From: Kerry Pham <kerryjo81@me.com>
Sent: Wednesday, September 7, 2022 5:05 PM
To: Gregg Harding
Subject: [EXTERNAL] Re: City of Pensacola Architectural Review Board Meeting / Pre-app Meeting Comments
Attachments: Draft Agenda.pdf

I was able to meet with the Architectural Review Board Chairman and Historic Trust Advisor to review the September 15 ARB agenda packet. They had the following comments for 917 N. Palafox Street:

Cross
Section

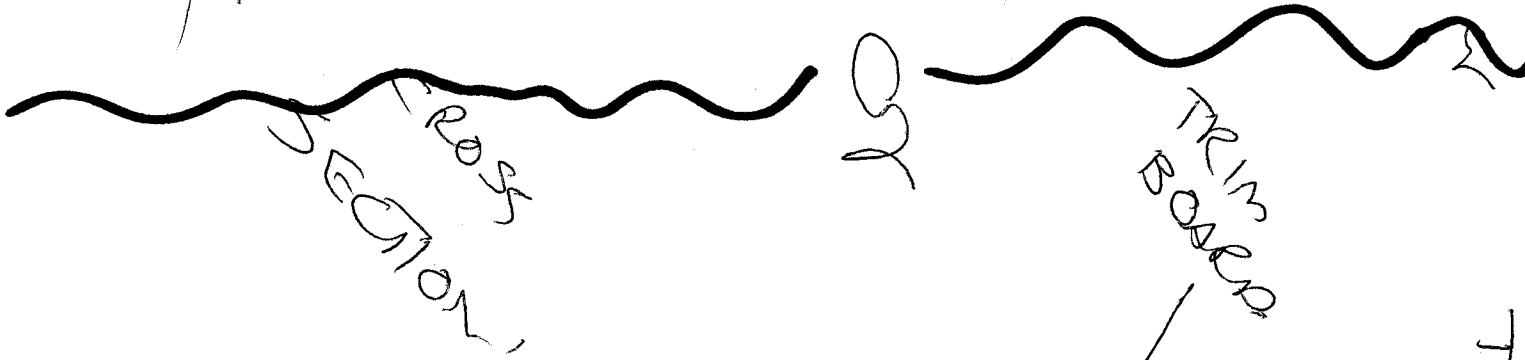
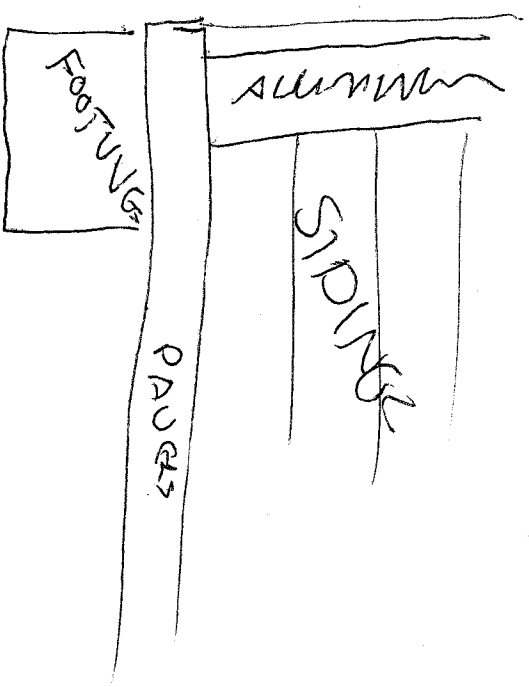
- *Please ask the applications for clarification on how the screen enclosure will connect with the rear of the building – will it be flush with the sides of the building, or will it be set inside the building's corner boards / trim?*

The contractor shows both ways below. We are happy to do it whichever way the ARB prefers.
